Value Planning Final Report

St. Mary Diversion and Headworks Infrastructure Replacement Addressing ESA Compliance

August 5, 2010

Figure 5 - Baseline Site Plan

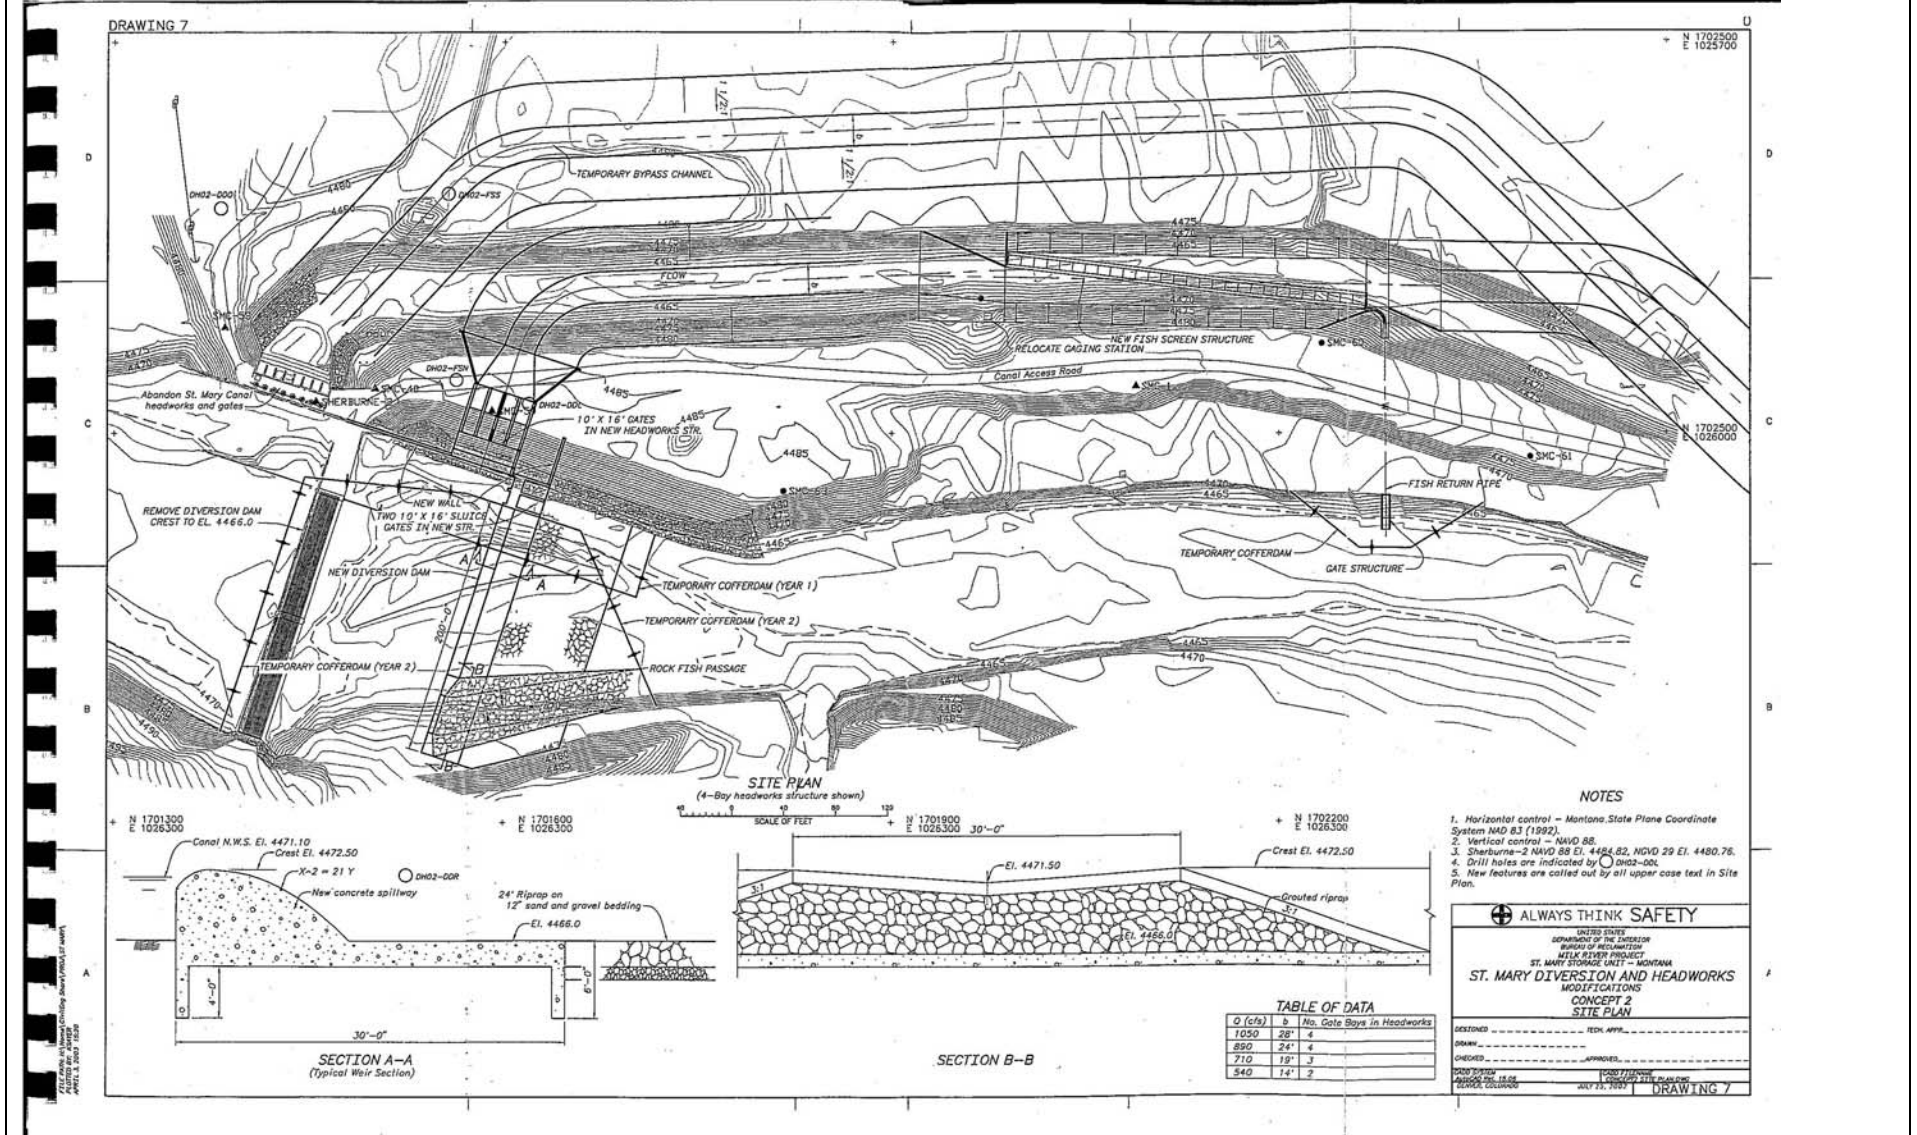
St. Mary Diversion – Replacement of existing facilities with single sluiceway diversion with rock ramp fishpass and vertical fish screen in canal downstream of new intake.

Alternative Description: All existing structures would be demolished and removed after the new facilities are complete and operational. A new concrete weir with ogee crest would be constructed across the river. The crest of the weir is set at elevation 4472.5 to provide diversion head similar to the existing diversion weir with the weir-boards installed. The weir length is approximately 200 feet. A sluiceway with two bays, each controlled by a 10-ft-wide by 16-ft-high radial gate, is positioned on the left weir abutment. The canal diversion and head-works is located on the left riverbank immediately upstream of the sluiceway. The canal diversion head-works, new canal section and new fish screen structure are shown in Figure 5. A rock ramp fishpass would be constructed along the right riverbank with a slope of 3.5 percent, representative of a more natural stream channel. A shallow “V” shaped channel in the center of the ramp provides a low-flow fish pass. Under progressively higher river flows, fishway flow spills over the fishway left bank providing increased attraction and access to the fishway.

New Concrete Dam would include: An ogee spillway crest set at elevation 4472.5. One sluice way located on the left riverbank.

New Canal Intake would include: Four-bay intake with head gate sill at elevation 4468. Adjustable log-boom debris deflector in front of the head gate opening and attached between sluiceway bays to guide floating debris out through the top-release sluice gate.

Figure 6 - Diversion Dam and Headworks Replacement Site Plan

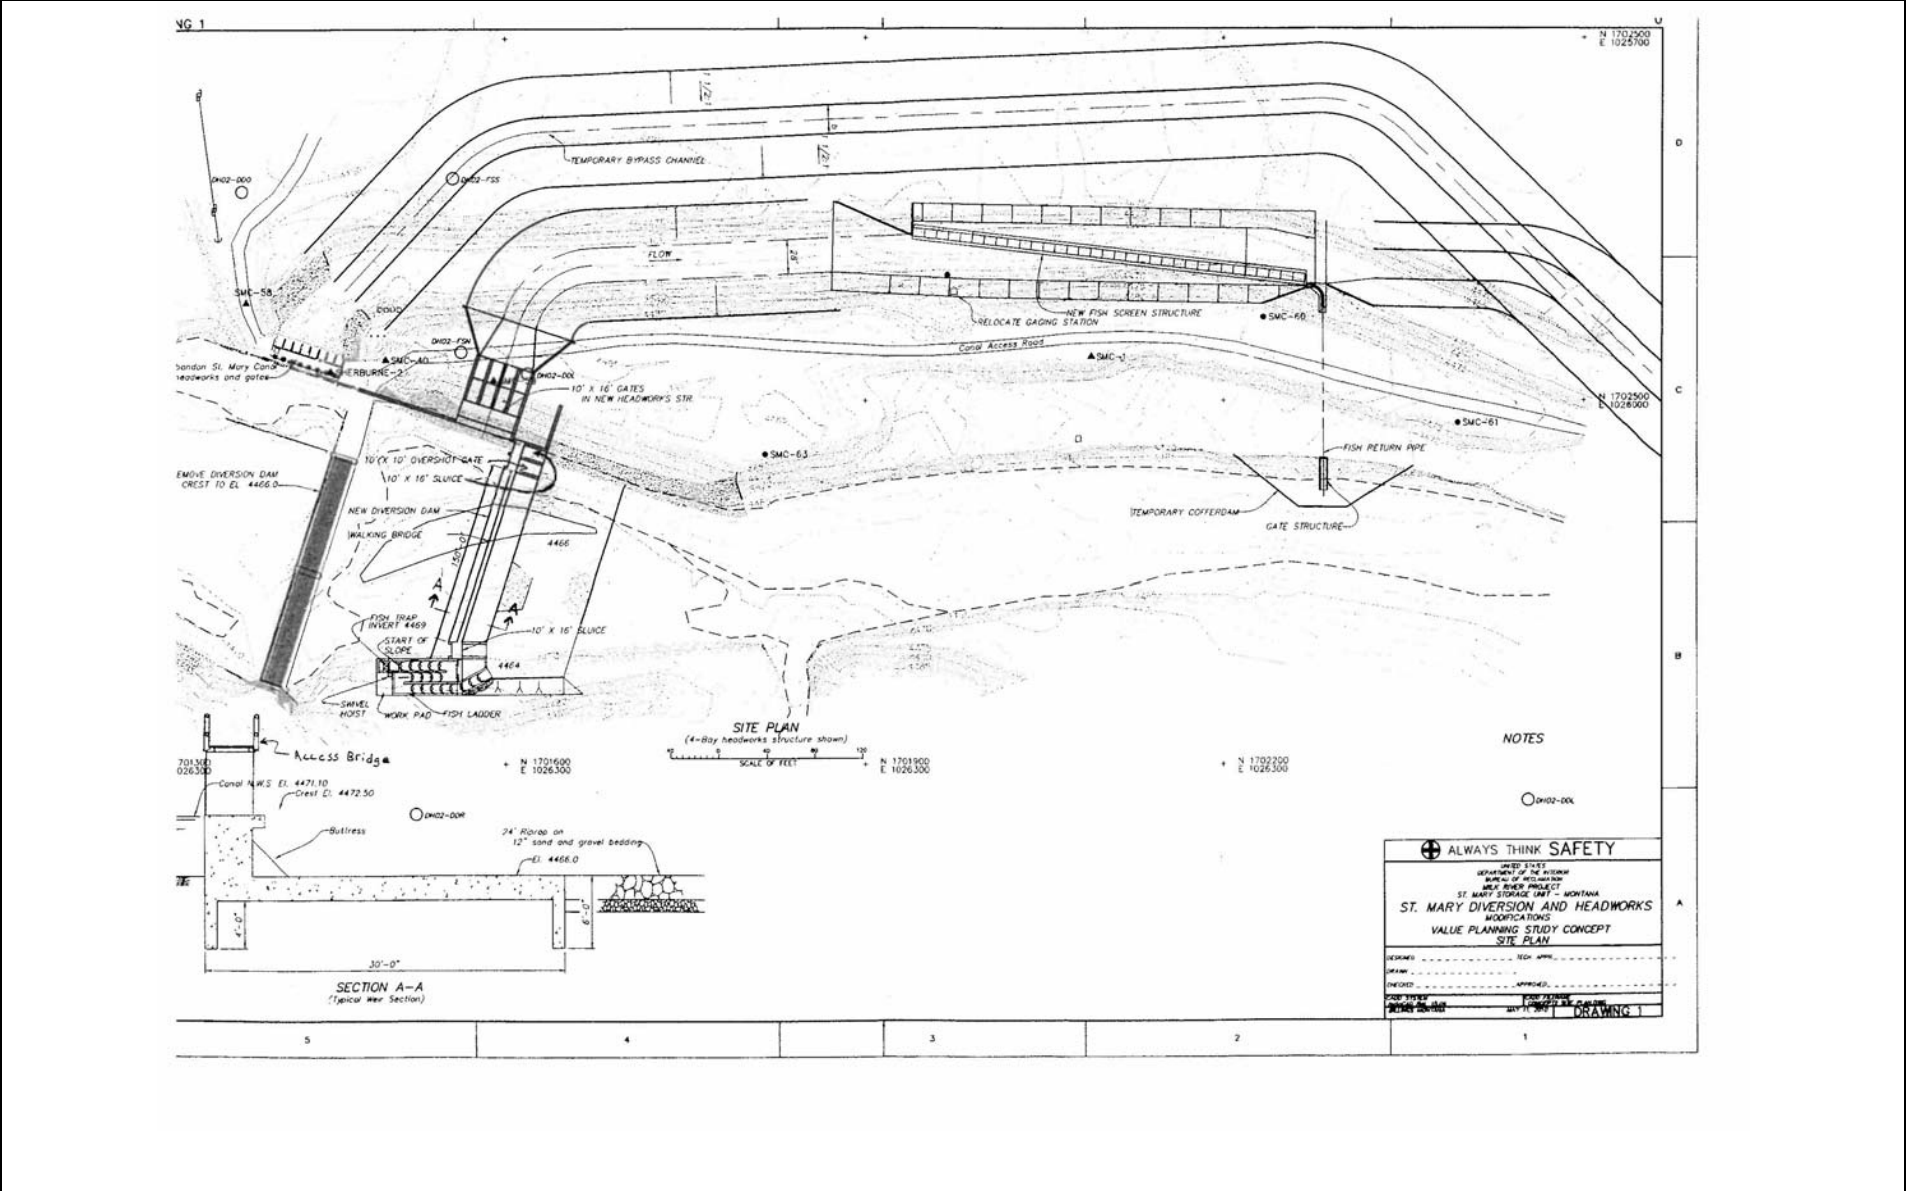
Alternative Description: The proposed alternative includes a number of elements from the original Baseline Design, including the 890 cubic foot per second (cfs) diversion, which allows for the original 850 cfs irrigation allocation and the additional 40 cfs required for fish return channel/pipe of fish screen. It also includes a concrete dam, low-gradient fishway, sluiceway, and head gate structure much like the original design. Sherburne Dam winter release concept would be retained as proposed. (See Figures 6, 7, and 8).

The new diversion dam consists of a cantilevered crest to block upstream fish passage. With new information on the potential threat of non-native walleye invasion from St. Mary Reservoir (downstream in Alberta), the Team felt that passage should only be permitted to native species. Invasion by a non-native, top-end predator species such as walleye could have catastrophic effects on native fish populations. For example, Lake Trout, another top-predator introduced in other areas of Bull Trout range has had serious impacts on native populations including significant impacts on Bull Trout west of the divide in Glacier National Park.

Additions would be included to the sluiceways to help ensure that fish do not move upstream while gates are open during periods of sluicing (i.e. winter). A second sluiceway was added to the opposite side of the dam to aid in dam and head gate maintenance and provides additional flows when needed to help guide fish to the ladder opening. A walking bridge was added to the concept to ensure access to the fish ladder and sluiceway on the east (river right) side of the channel.

1. Permanent crest is set at the existing 4472.50-foot (ft) elevation, and allows for attachment of Optional Adjustable Crest to upper surface (see next proposal).

2. Dual sluiceways with one on each side of the river. The river-left sluiceway will consist of two bays. One bay will be opened (sluiced) from the bottom and the other bay will be opened (sluiced) from the top to aid in removal of bottom sediment and floating debris. The river-right sluiceway will consist of one bottom-release bay to aid in fish attraction at the ladder entrance.

3. Sluiceway invert elevations will be raised from 4466 to approximately 4468 with cantilevered lip (overhang) fish-barrier at downstream edge of sluiceway. Drop and overall length of downstream concrete apron must be adequate to provide velocity barriers to fish passage.

4. Entrance to headworks will be raised, but will not reduce water delivery to the canal.
5. Concrete Fish Ladder constructed on river right abutment (east side) and a crowding/collection/trap box at upstream end to allow for monitoring and selective fish passage.
